Technical Memorandum

Subject: Review and Update to Preliminary FEMA Hydrologic Analysis for San Luis Obispo Creek Physical Map Revision

Brendan Clark, PE
Supervising Water Resources Engineer
Department of Public Works
County of San Luis Obispo

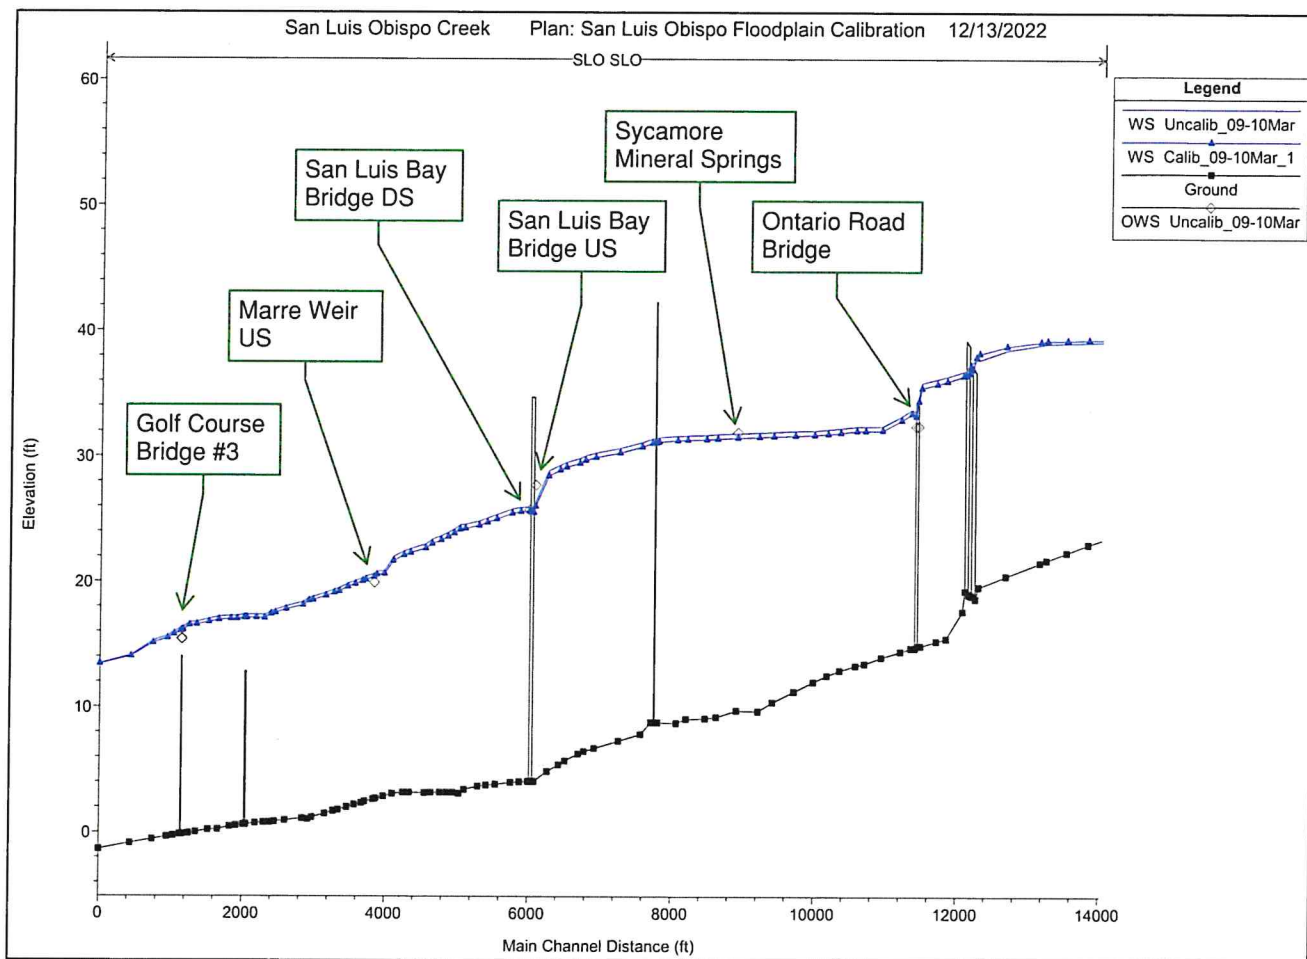
The 9-10 March 1995 storm scenario was then run through the calibrated basin model. The resulting flows were input into the RAS calibration flow file for comparison with the uncalibrated flows. Profile results from the calibrated and uncalibrated flows are shown in the figure below:

The calibration generally improved the performance of the hydraulic model in corresponding with recorded HWMs. The remaining variation can be reasonably attributed to physical changes since 1995. In particular, the San Luis Bay Drive Bridge has since been replaced, explaining the discrepancy in upstream behavior. However, the downstream calibrated elevation showed good agreement with the historical HWM. Additionally, at the time of the March 1995 flood event, the Ontario Road bridge was newly constructed and not fully complete. Notably, the bridge rail guards had not been installed. Extrapolating from the modeled downstream water surface profile leads to excellent agreement with the Ontario Road bridge HWM. No further reductions in loss parameters were deemed justified due to residual uncertainty with topographic and manning's roughness assumptions.
